Item Name: Window

Work Order ID: 93792

DRAWING NO.
D3290
REV. C
SHEET 1 OF 2
TITLE
REPLACEMENT WINDOW ASSEMBLY
SCALE
1:5

DRAWING NO. D3290	TITLE REPLACEMENT WINDOW ASSEMBLY	REV. C	DART AEROSPACE LTD ENGINEERING ORDER		D.E.O. NO. D3290-C-1	SHEET NO. SHEET 1 OF 1	SCALE NTS
DRAWN <i>qp</i>	CHECKED <i>ls</i>	MFG. APPR. <i>E</i>	APPROVED <i>MD</i>	DE APPR. <i>th</i>			
DATE 09.09.18	DATE 09.09.18	DATE 09.09.18	DATE 09/09/21	DATE 09/09/21

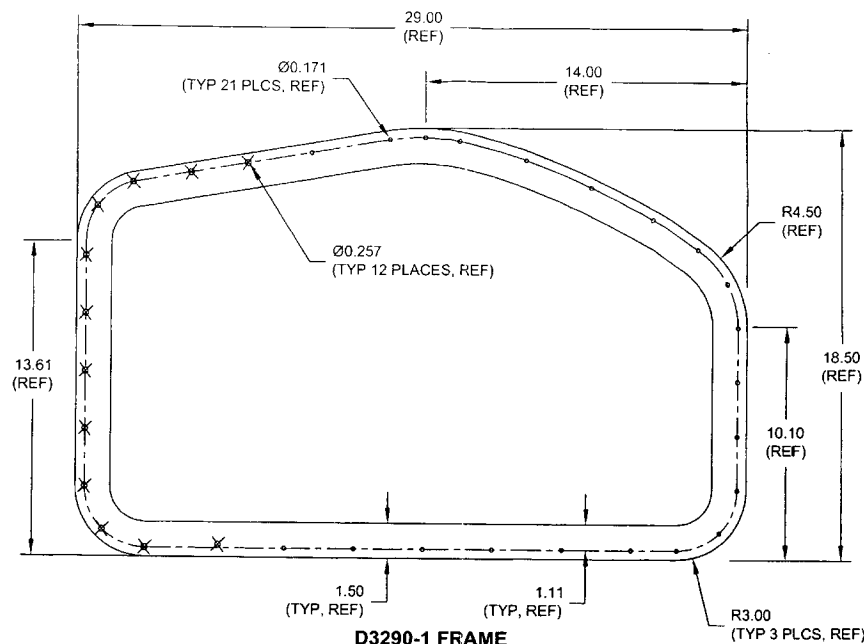
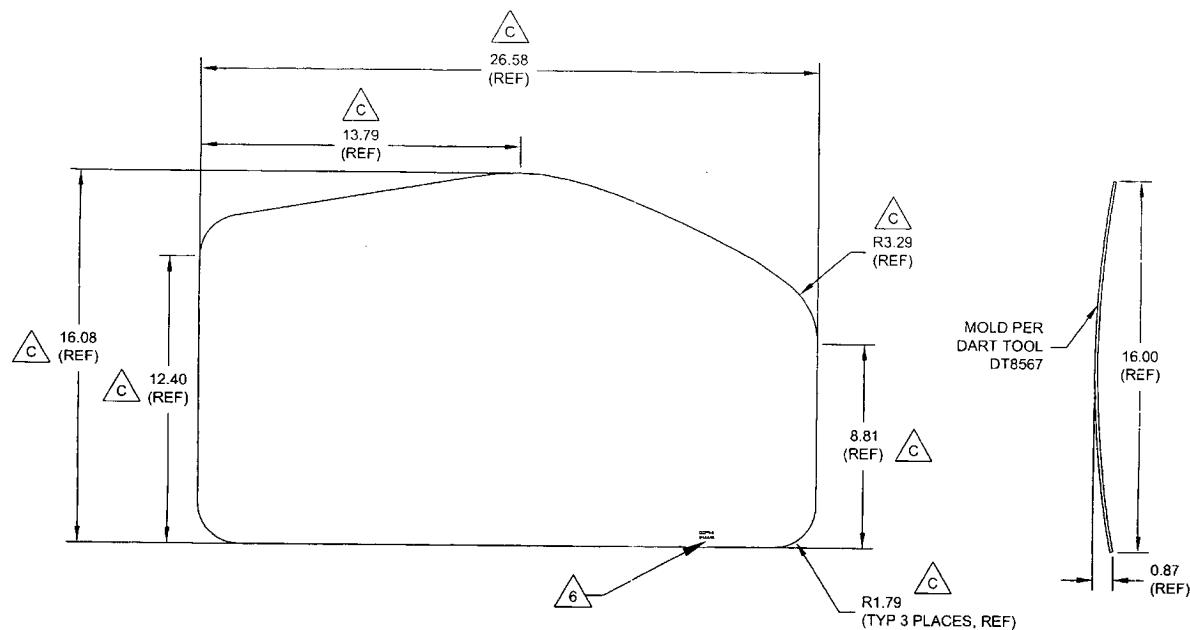
CHANGE MATERIAL THICKNESS OF D3290-1 FRAME TO 0.063 FROM 0.040. REF PAR 09-033.

MATERIAL CALL-OUT OF D3290-1 FRAME ON SHEET 1 IS AMENDED AS FOLLOWS:

- 1) MATERIAL: 6061-T6 (OR 6061-T62) ALUMINUM SHEET ~~0.040 THICK~~ 0.063 THICK (REPLACE)
PER AMS-QQ-A-250/11 OR AMS 4025 OR AMS 4027
~~(REF. DART SPEC. M6061T6S.040)~~ REF. DART SPEC. M6061T6S.063 (REPLACE)
OR
5052-H32 ALUMINUM SHEET ~~0.040 THICK~~ 0.063 THICK (REPLACE)
PER AMS-QQ-A-250/8 OR AMS 4016
~~(REF. DART SPEC. M5052H32S.040)~~ REF. DART SPEC. M5052H32S.063 (REPLACE)
